PIC18F26/46/56Q83 Silicon Errata and Data Sheet Clarifications

PIC18F26/46/56Q83

The following typographic corrections and clarifications are to be noted for the latest version of the device data sheet (DS40002253**D**).

1.6.1. UART TXDE Signal May Go Low Before the STOP Bit Has Been Entirely Transmitted

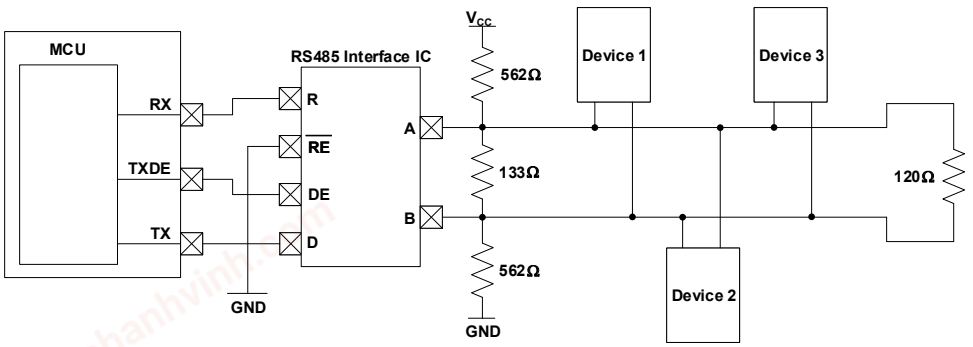
The UART Transmit Drive Enable (TXDE) signal could potentially transition into a low state before the UART Stop bit has been entirely transmitted due to the effects of parasitic capacitance on the TX line. In some applications, this could result in communication being prematurely terminated due to the TXDE signal going low before the STOP bit has had enough time to settle.

To ensure that the Stop bit settles into its final logic state before the TXDE signal transitions low, a biasing circuit can be implemented. A biasing circuit allows the TX line to either be driven high or low, rather than being left in a floating tri-state mode, where prolonged rise or fall times could lead to communication being disrupted. This bias circuit must only be implemented on one end of the serial bus, and a termination resistor must be used on the other end. The figure below shows an example of a bias circuit that can be used to achieve this.

Please note that the resistor values used in this circuit are recommendations and that the actual resistor values required may vary based on the application.

48-Lead Plastic Thin Quad Flatpack (Y8X) - 7x7x1.0 mm Body [TQFP]

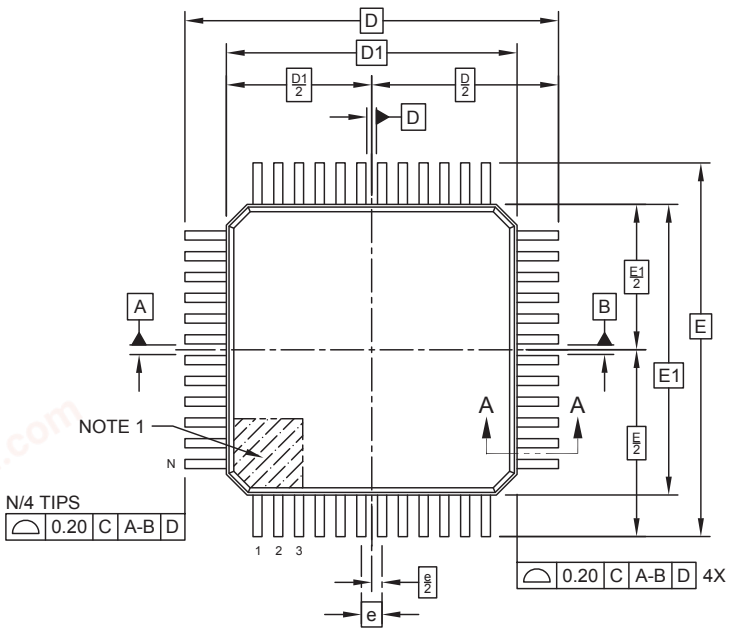
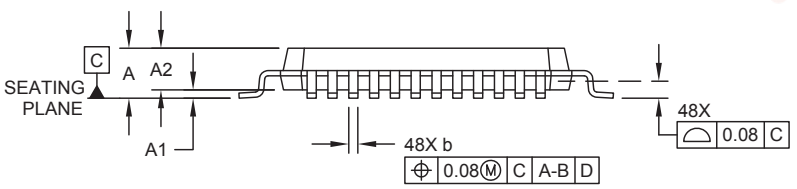
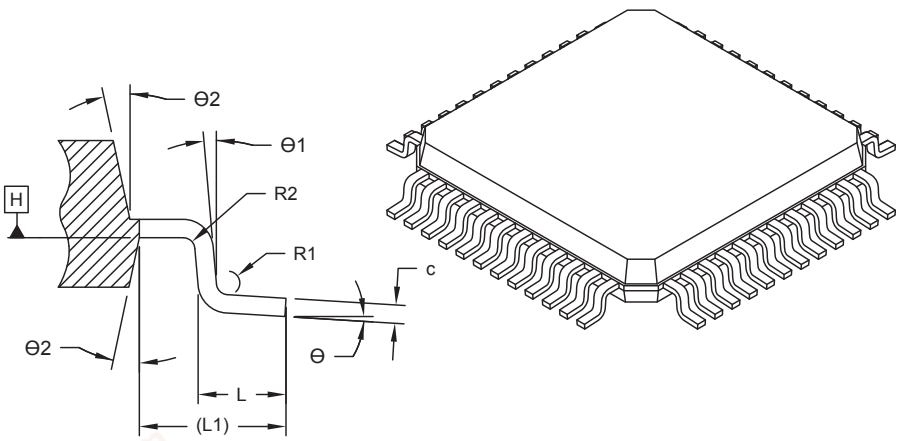
The data sheet lists the incorrect package drawing for the 48-lead TQFP package. The correct package drawings are shown below:
